City of Sugar Hill
Planning Staff Report
CBD Design Review 20-00703

DATE: August 12, 2020
TO: Mayor and Council, Design Review Board
FROM: Planning Director
SUBJECT: Central Business District (CBD) Design Review
Lidl US – NW corner Nelson Brogdon Blvd. and Sycamore Road

Right Elevation (facing Nelson Brogdon Blvd)

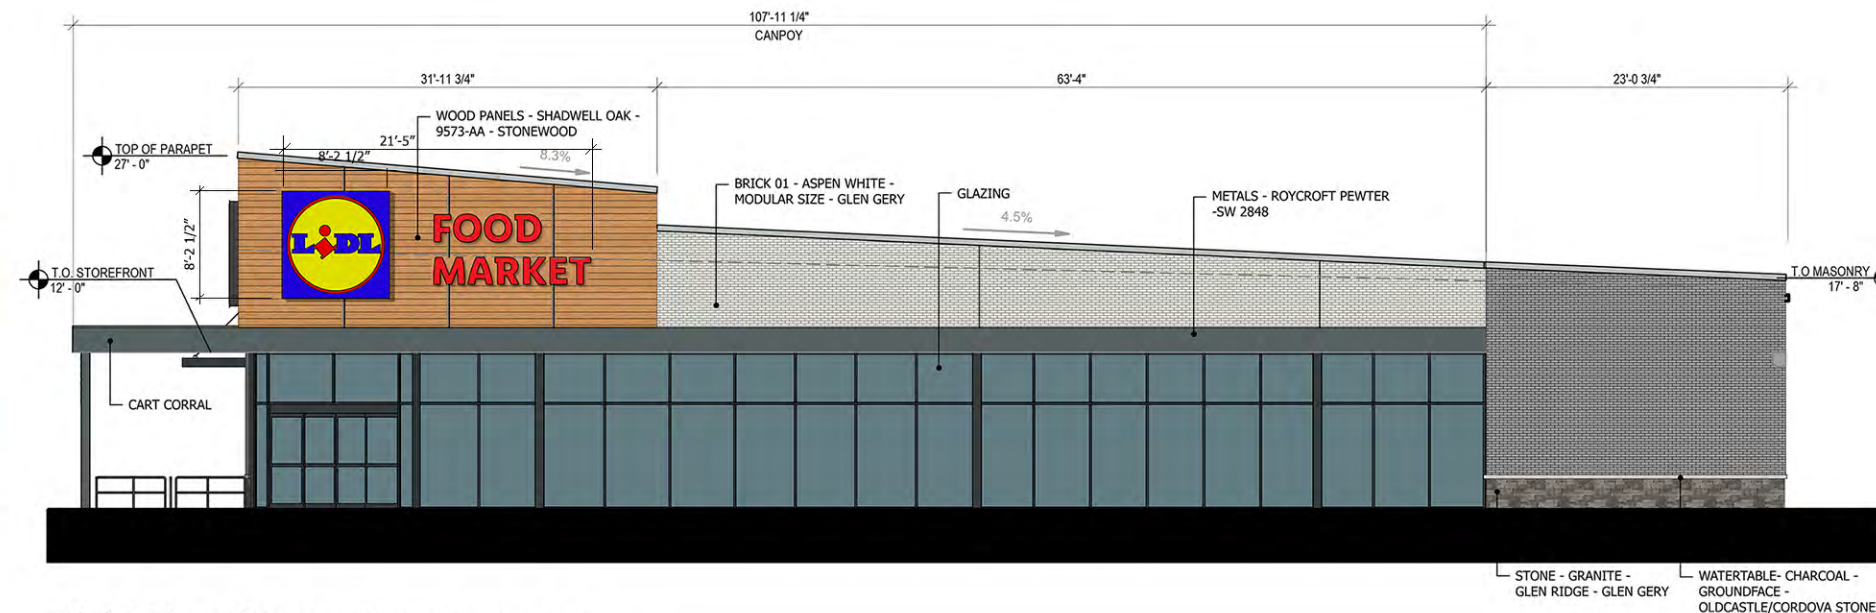
- 2) A maximum dimension in the façade articulation to protect against the dulling effect of blank walls adjacent to the streetscape and other pedestrian areas surrounding the building;

- 3) A minimum window and door coverage along street-facing facades to provide a visual connection from the building and its uses to the streetscape promoting a sense of welcome and security; and

- The building's proximity and orientation to Highway 20 may be valid reasons to deviate from those standards. However, the applicant's choice of interior building layout and operations are driving the need to request variances related to the transparency and entrance requirements.

Rear Elevation (facing Sycamore Road)

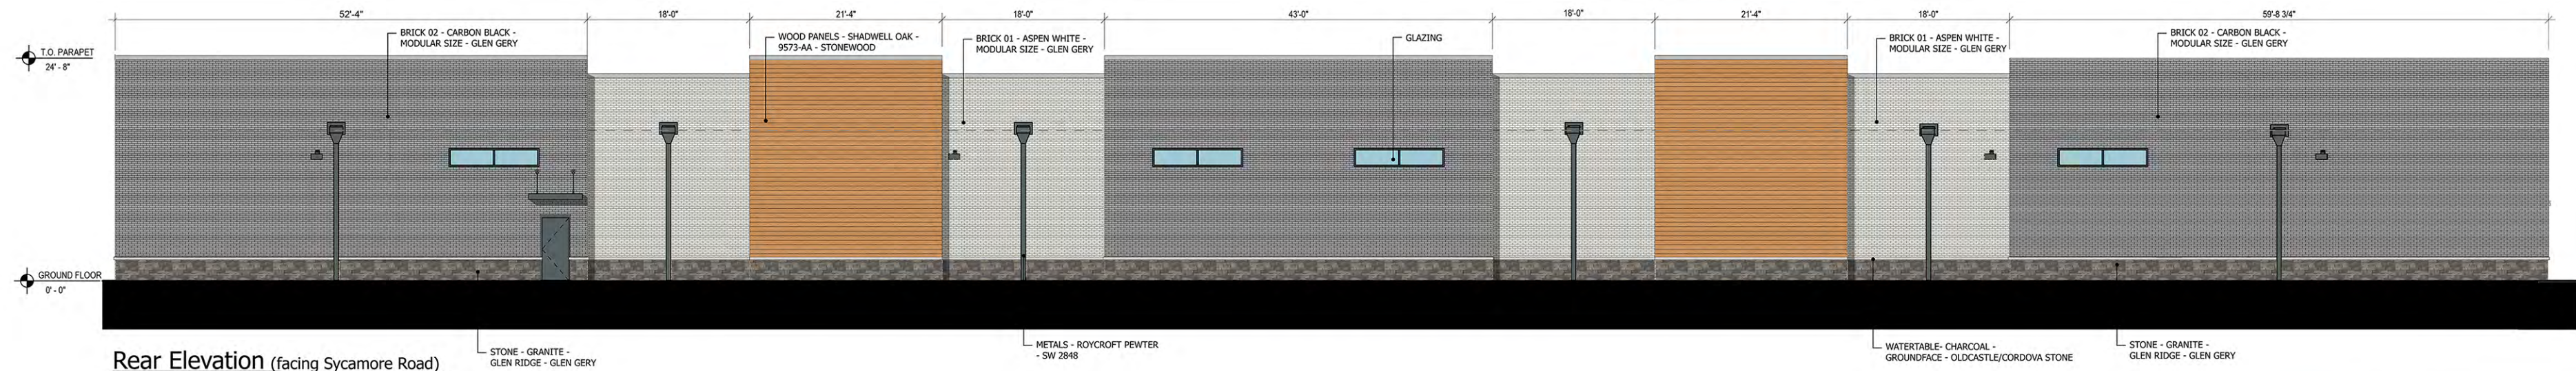
4. Landscaping along Sycamore Road shall be arranged to screen the building panels in no less than 20' increments. Landscape strip shall consist of at least two staggered rows of evergreen and semi-evergreen trees and shrubs native or adapted to the area. Trees shall be 6' tall at time of planting. Plantings shall be arranged to provide an effective visual screen of at least 20' in height at maturity. Landscape strip must not contain more than 1/3 of a single species and must be shown on a landscape plan to be approved by the city manager prior to receiving any permits.
